# EMERGENCY AIRWORTHINESS DIRECTIVE

**DATE: November 28, 2003**  
**AD #: 2003-24-51**

**2003-24-51 ROBINSON HELICOPTER COMPANY: Docket No. 2003-SW-48-AD.**

Applicability: Model R44 and R44 II helicopters, certificated in any category.

Figure 1

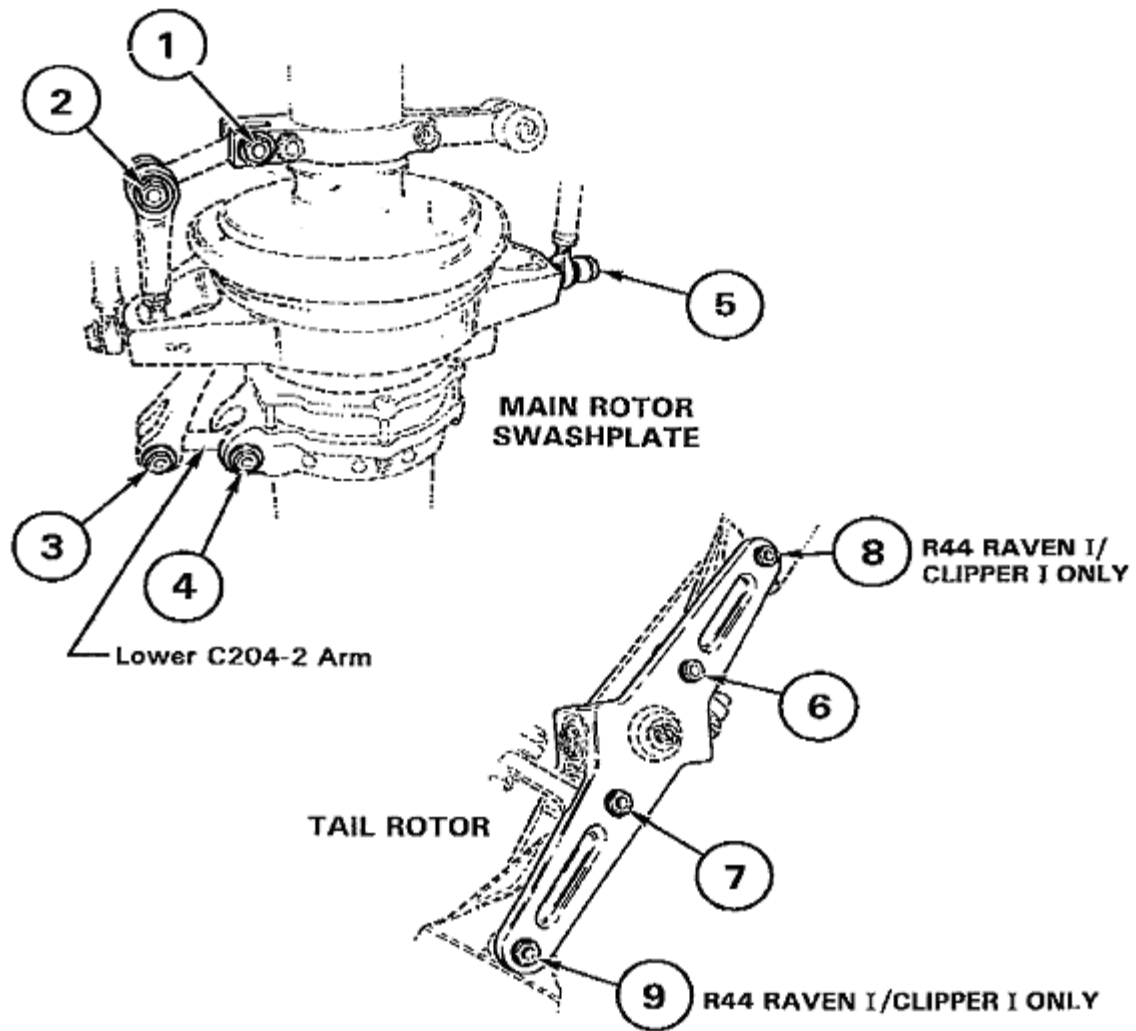
(1) Determine if maintenance has been performed after February 7, 2003 on the areas specified in Figure 1 of this AD, and determine if any bolt, part number (P/N) NAS6605-31, shown in Figure 1 has been replaced for any reason.

(1) Visually inspect each bolt for fretting residue under the bolt head, which indicates a loose, potentially cracked bolt.

(2) Apply 10-15 ft-lb (13-20 Nm) torque to each bolt head and verify no rotation. See Figure 1 of this AD.

Suspect NAS6605-31 Bolts

9 Place on R44

7 Places on R44 II

(3) If residue or rotation of the bolt is found, before further flight, replace each unairworthy bolt with an airworthy bolt that does not have a vendor identification marking of 01DO.

(e) For the helicopters specified in paragraphs (b) and (c) of this AD, within 10 hours time-in-service or by December 31, 2003, whichever occurs first, replace each bolt, P/N NAS6605-31, that has vendor identification marking 01DO on the bolt head, with an airworthy bolt, P/N NAS6605-31, that has an alternate vendor identification marking.

(f) Bolt, P/N NAS6605-31, with vendor identification marking 01DO on the bolt head, is NOT ELIGIBLE for installation on any helicopter.
